MANDATORY
SERVICE BULLETIN

Service Bulletin No. 548
Engineering Aspects are
FAA Approved

SUBJECT: Diaphragm-Type Fuel Pump Inspection/Replacement

Figure 1

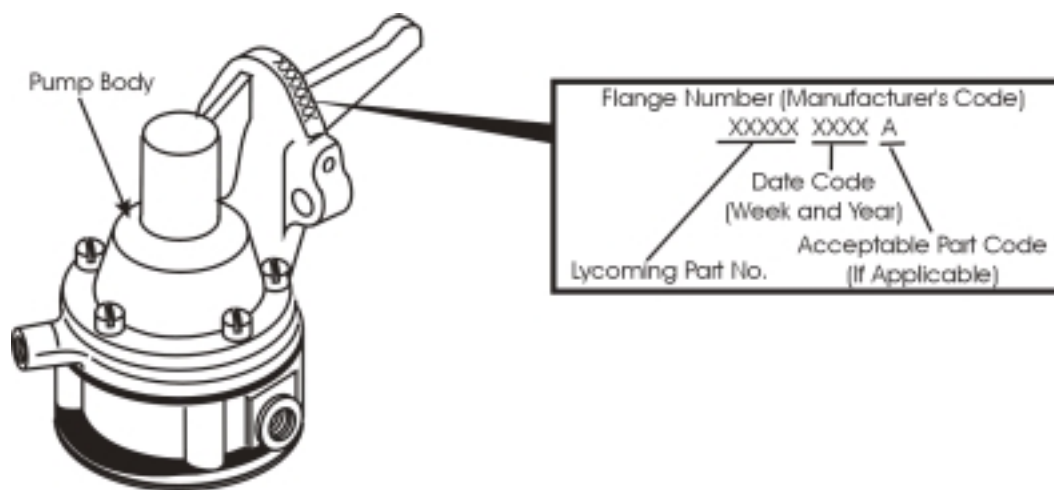
To identify affected pumps, check the manufacturer's code scribed on the flange of the pump (See Figure 1). If the first five digits are 15472, 15473, or 16335, and the 6th through 9th digits are 3900, 4000, 4100, 4200, 4300, 4400, 4500, 4600, 4700, 4800, 4900, 5000, 5100, 5200, 0101, 0201, 0301 or 0401, the pump is affected and must be replaced.

If the letter "A" is marked as a suffix to the date code, the pump has been brought into conformity and need not be replaced.

If your Textron Lycoming engine has a diaphragm-type fuel pump with Lycoming P/N LW-15472, LW-15473, or LW-16335 installed, and has a date code of 3900 through 0401, the pump must be replaced within the next 100 hours of operation or 180 days from the date of this Service Bulletin, whichever occurs first.
